KARACHI MUNICIPALITY.

M E M O / -

~~The~~ With reference to his application dated 22nd received on 25th March 1918 with amended plans for plot No. 28, B-21 Serai Quarter Mr: Dwarkadas Jethanand is informed that more window area is required as shown in red on the plan and the drain must be laid in cement concrete where it passes through the building.

AMENDED PLAN OF BUILDING

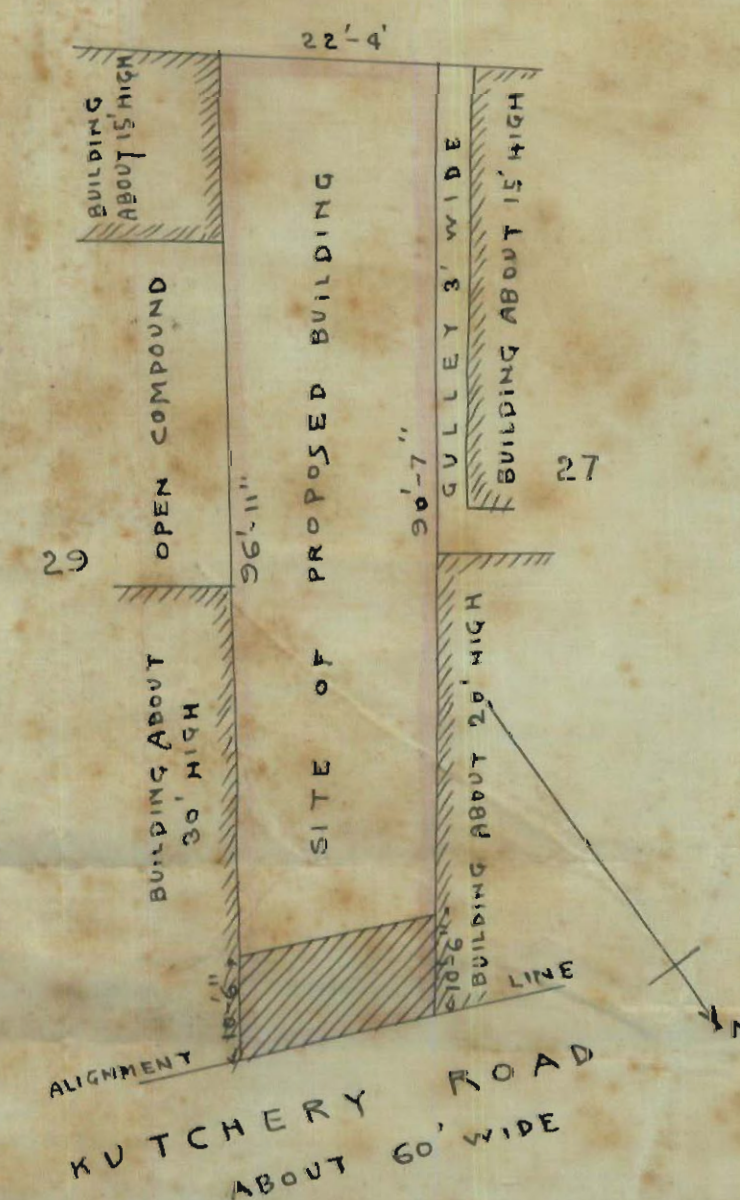
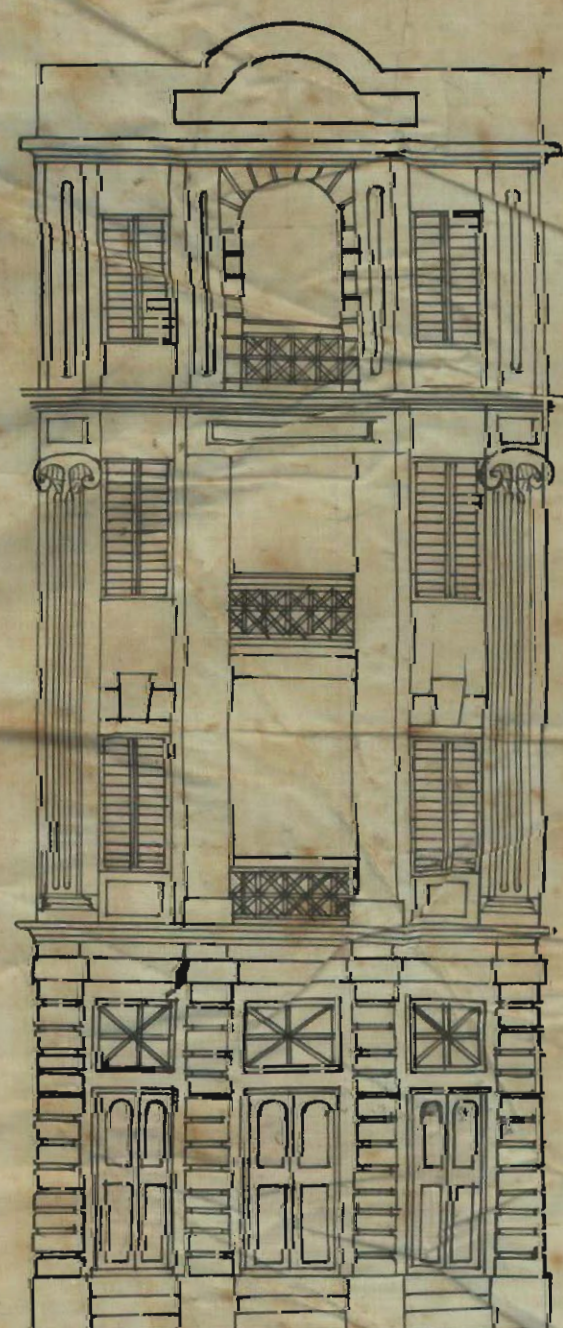
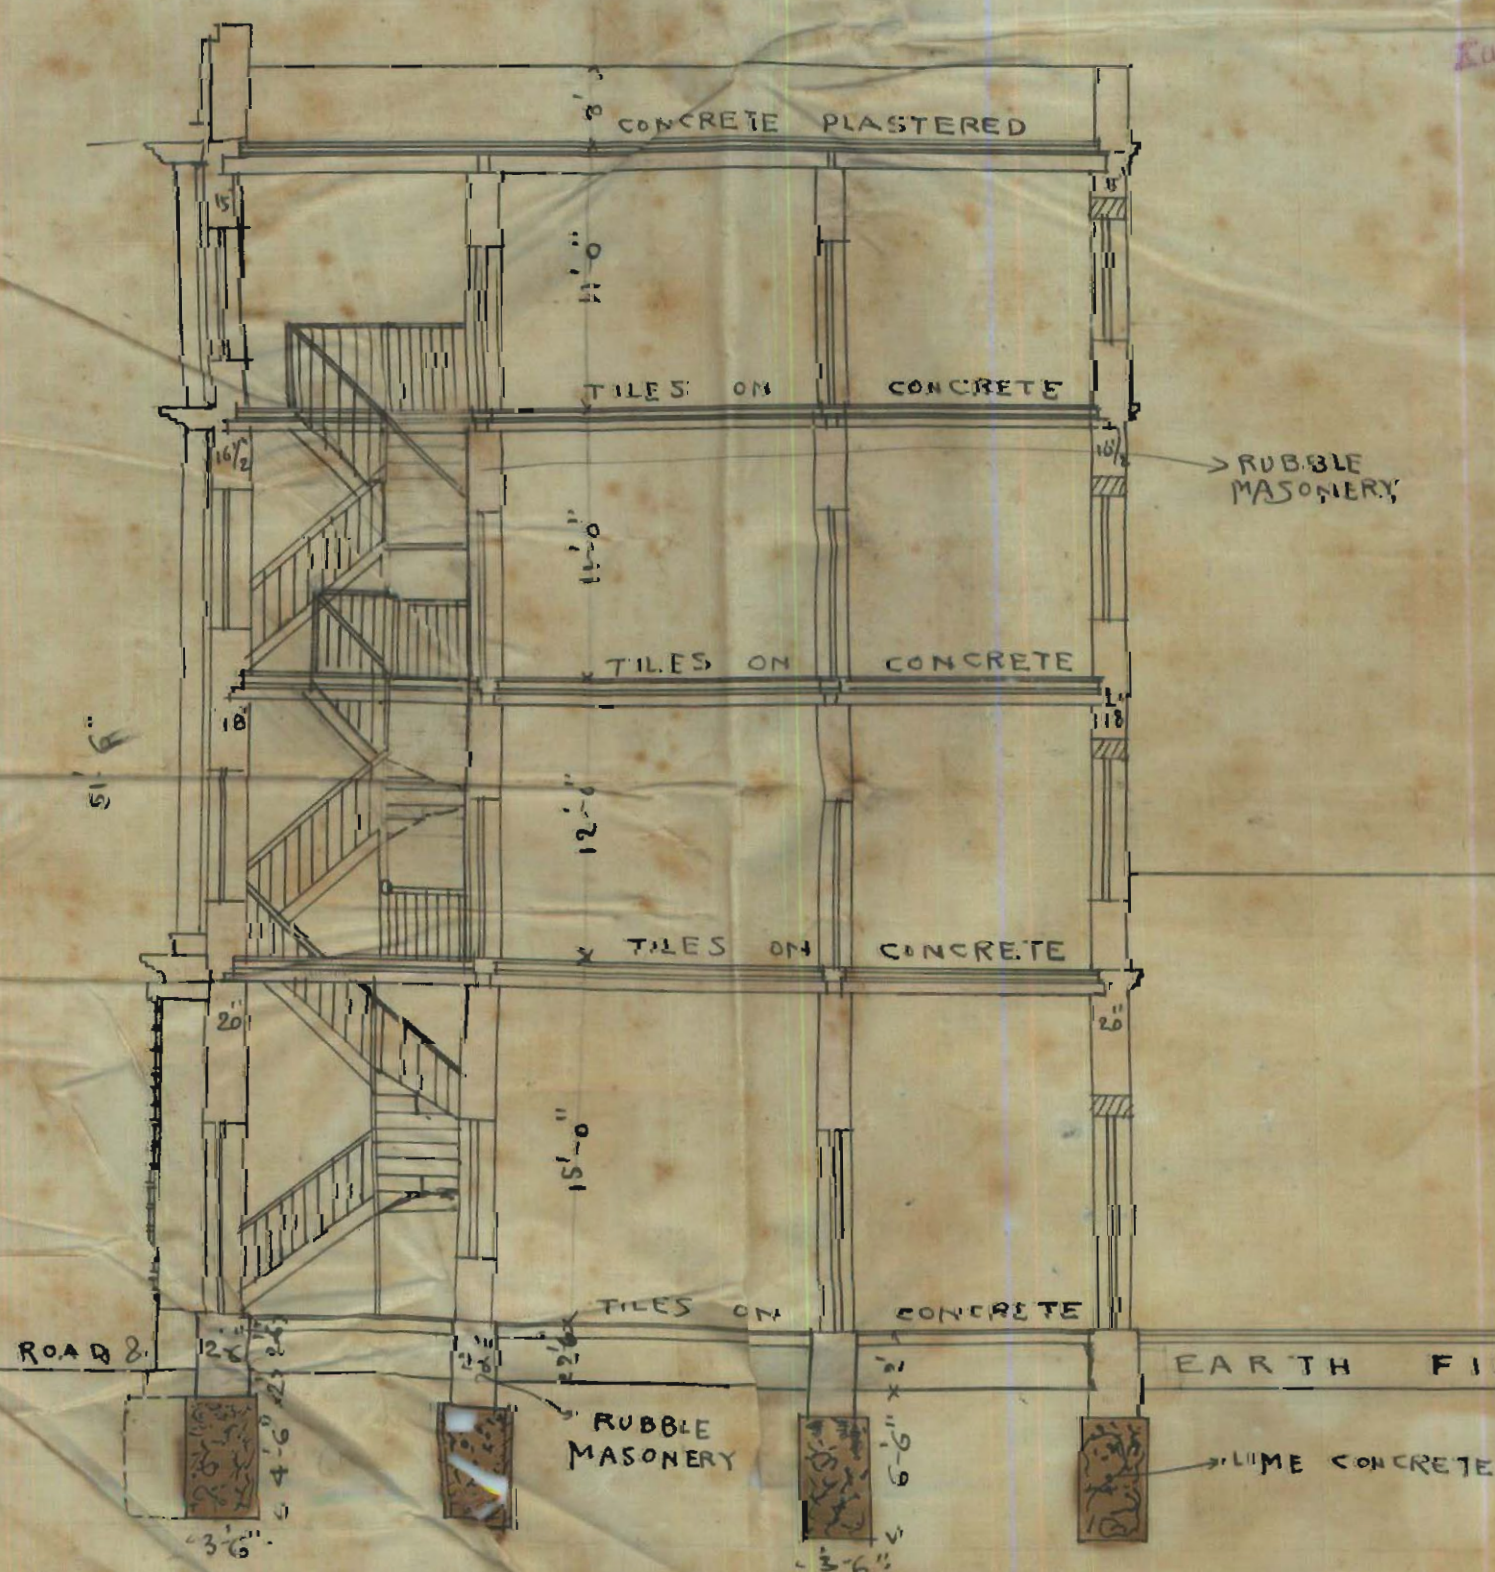
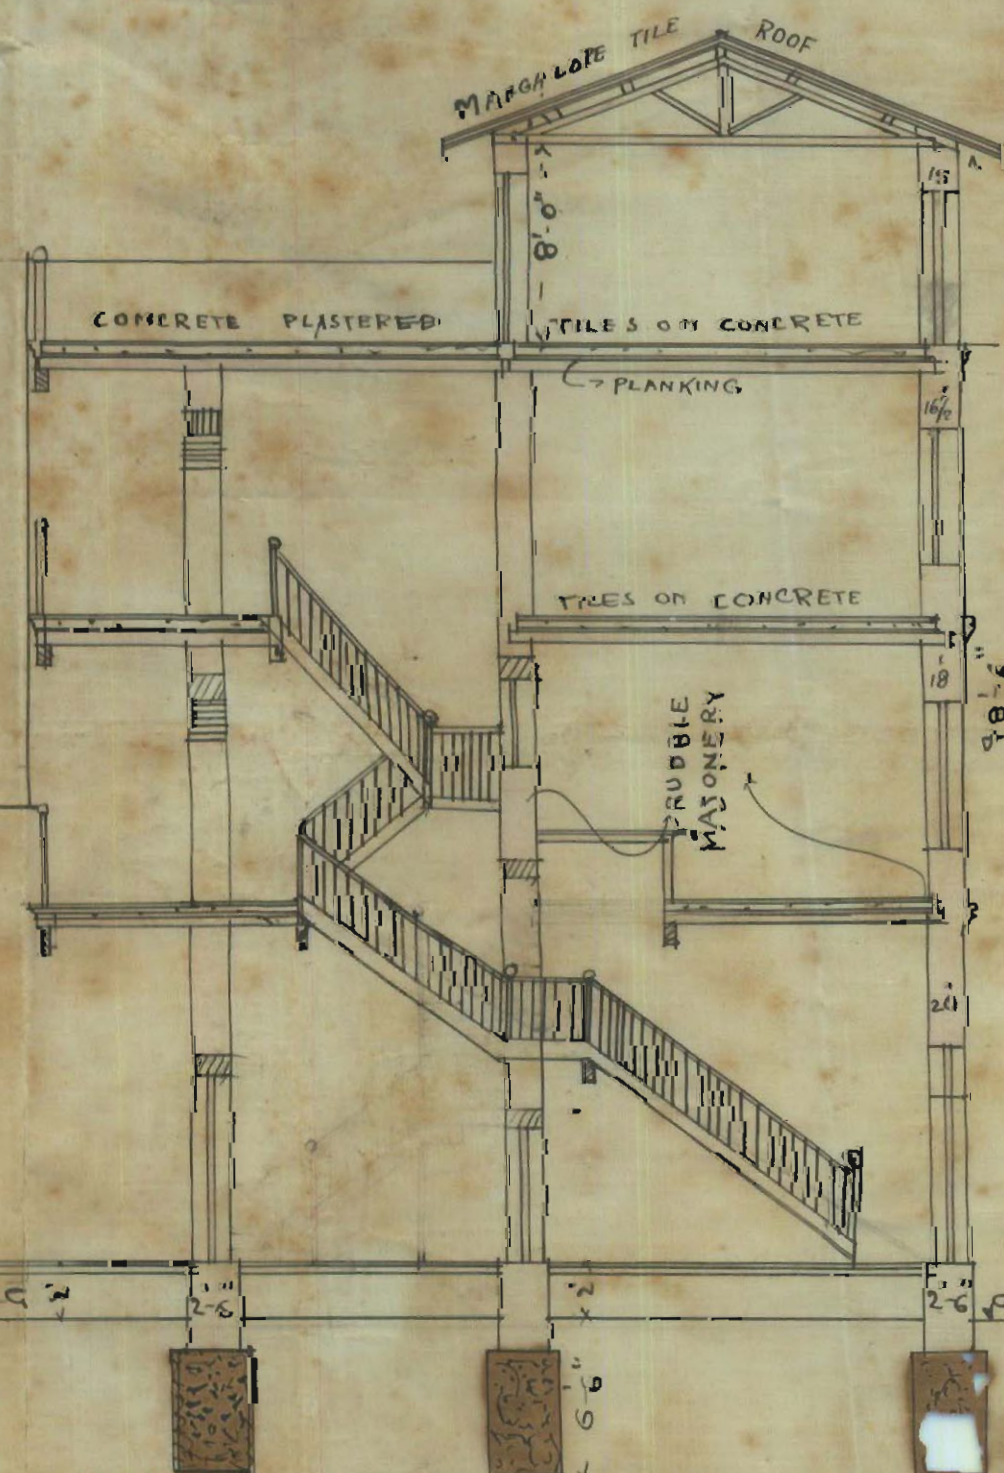
Mr. Dwarkadas Jethanand is informed that it is observed that he has opened some windows in the portion of the Western wall of his building under construction on plot No. 23 B 21 Sexxi Quarter which overlook on the adjoining plot. As these windows have been erected contrary to the sanctioned plan as well as the amended plan submitted for approval instructions are hereby given him to block up the same or steps will be taken under to do the needful at his risk and cost.

There window area
is required as shown
in set on the plan
& the drain must be
laid in ~~and~~ ~~concrete~~
where it passes thro'
the building.

Sir, with reference to your No S.3637 of 25th April '18, I beg to resubmit amended plans for building on plot No 28 Sheet B.21 Serai Quarter. The original sanctioned plan shows only one window and I beg to request that the new plan may also be approved with one window as shown in the plan.

The drain will be embedded in cement concrete as directed.

The open space has been increased slightly and taking this into account, I hope you will see your way to approve of the plan.

The only deviation from approved plan consists in the position of the conveniences which are to the north instead of being put to the south as in the approved plan. Windows to the rooms on the west wing have not been provided on the ground floor, as it was found that the position of the windows of the plot to the north would make the rooms disagreeable to live in.

The open space has been increased from 21' x 11'0" to 22' x 11' by diminishing the width of the gallery to the north.
